IBC - Fire Safety

2025 GROUP B PROPOSED CHANGES TO THE I-CODES

April 27 – May 6, 2025
Doubletree by Hilton
Universal Orlando - Orlando, FL

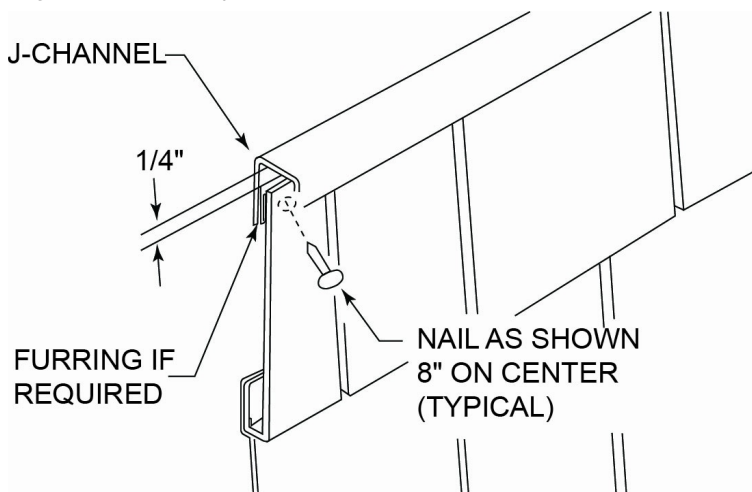
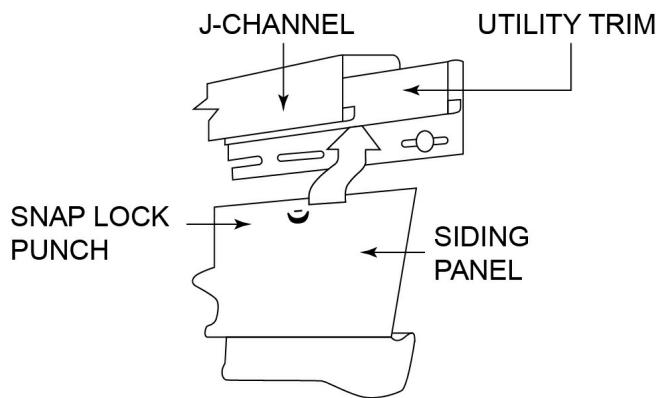
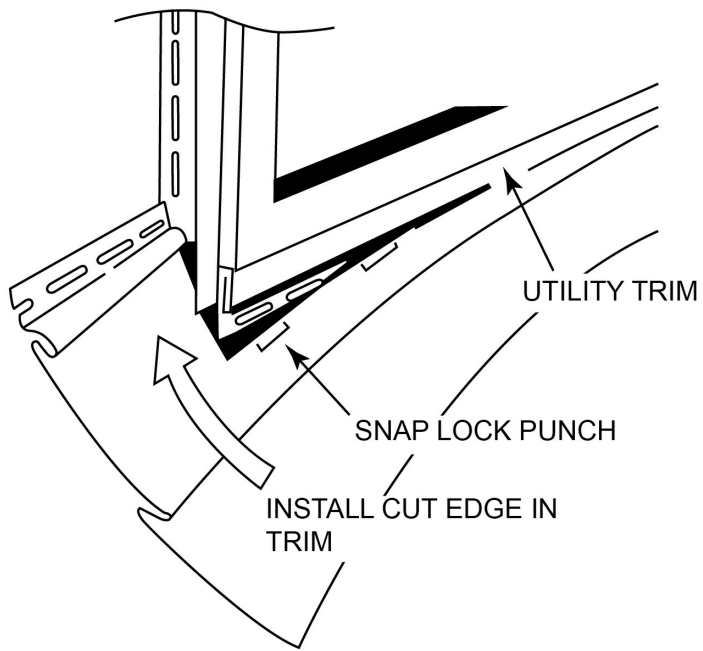
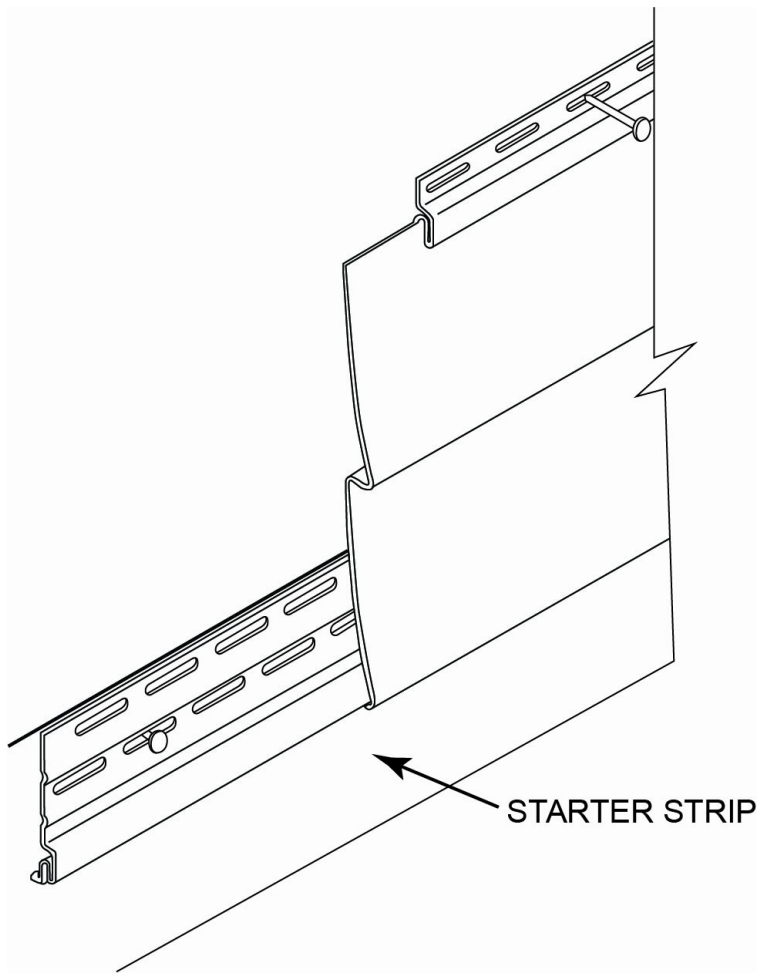
[BS] 1404.15.1 Application. The siding shall be applied over sheathing or materials listed in Section 2304.6. Siding shall be applied to conform to the *water-resistive barrier* requirements in Section 1402. Siding and accessories shall be installed in accordance with the approved manufacturer's instructions and the following:

1. Horizontal siding shall be installed with a starter strip at the initial course at any location.
2. Under windows, and at the top of walls, utility trim shall be used with snap locks.

[BS] 1404.18.1 Installation. *Polypropylene siding* and accessories shall be installed over and attached to *wood structural panel sheathing* with *nailable substrate* not less than $\frac{7}{16}$ inch (11.1 mm) in thickness or other substrate suitable for mechanical fasteners in accordance with the approved manufacturer's instructions and the following:

1. Horizontal siding shall be installed with a starter strip at the initial course at any location.
2. Where nail hem is removed for application under windows and top of walls, nail slot punch or pre-drilled holes shall be constructed for the fasteners.

Reason: This change provides critical installation point requirement, that ensure system performance. These areas have been noted in the field as missing in some cases. By adding them, the code will require these specific connection points and by do so doing create more durable structures. Below are the drawings adopted by the IRC and also adopted by the Florida Residential Code. These drawings could be offered as part of the proposal as well, but based on input from the committee last year, I thought starting with simple language might be more acceptable.

FIGURE 1404.14.2(1) OVERHANG RATIO

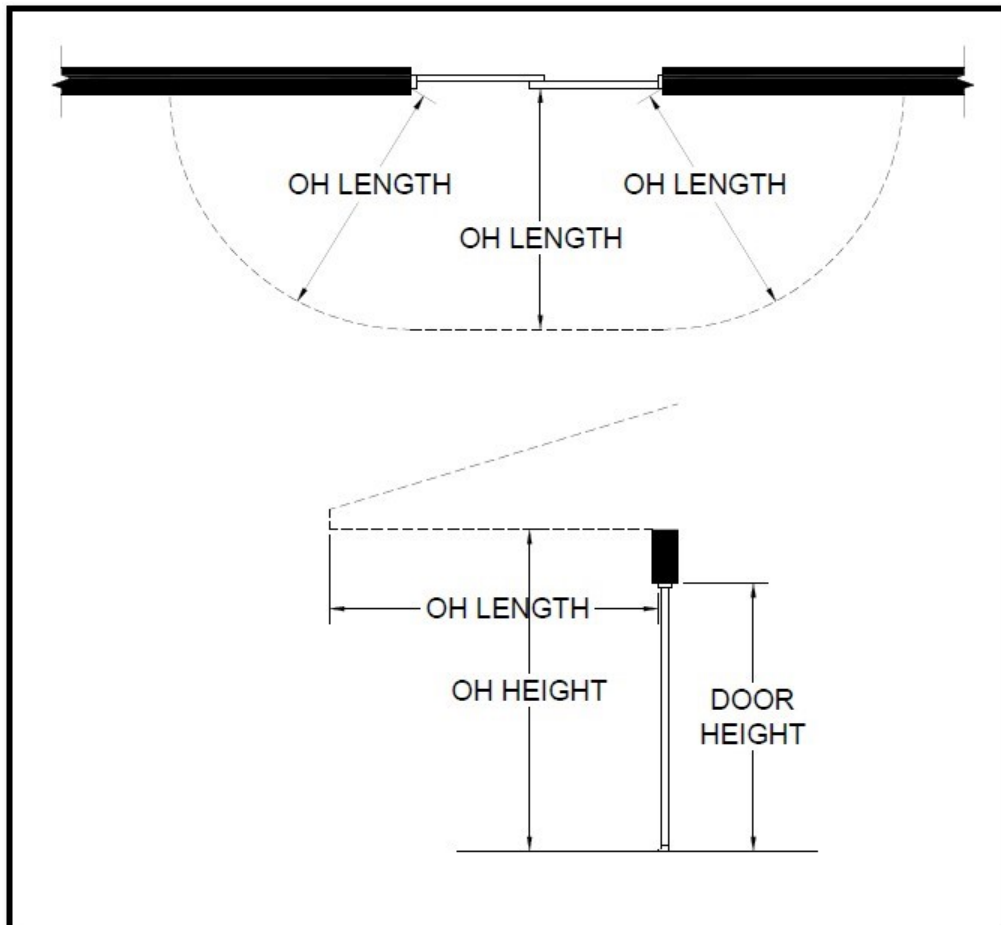
1404.14.2 Door systems with a Limited Water (LW) Rating. Door systems labeled with a Limited Water (LW) rating as specified in AAMA/WDMA/CSA 101/I.S.2/A440 shall require additional water exposure protection by an overhang with an OH Ratio greater than or equal to 1.0, approval by a registered design professional, or by other approved methods. The OH Ratio, as depicted in Figure 1404.14.2(1), shall be determined in accordance with the following equation: $OH\ Ratio = OH\ Length / OH\ Height$ Where: OH Length = The minimum horizontal projection of the permanent overhang measured from the nearest portion of the door face. OH Height = The maximum vertical distance from the elevation of the bottom of the door to the underside of the outer edge of the permanent overhang over the door.

Reason: The proposed code change introduces a requirement for doors labeled with a Limited Water (LW) rating under standard AAMA/WDMA/CSA 101/I.S.2/A440 (NAFS). The Limited Water (LW) designation specifies products intended for use in locations where adequate protection from water exposure is provided. Currently, the code has no additional requirements for LW-rated windows as the NAFS standard recommends. This proposal seeks to integrate this designation into the building code with clear door overhang criteria,
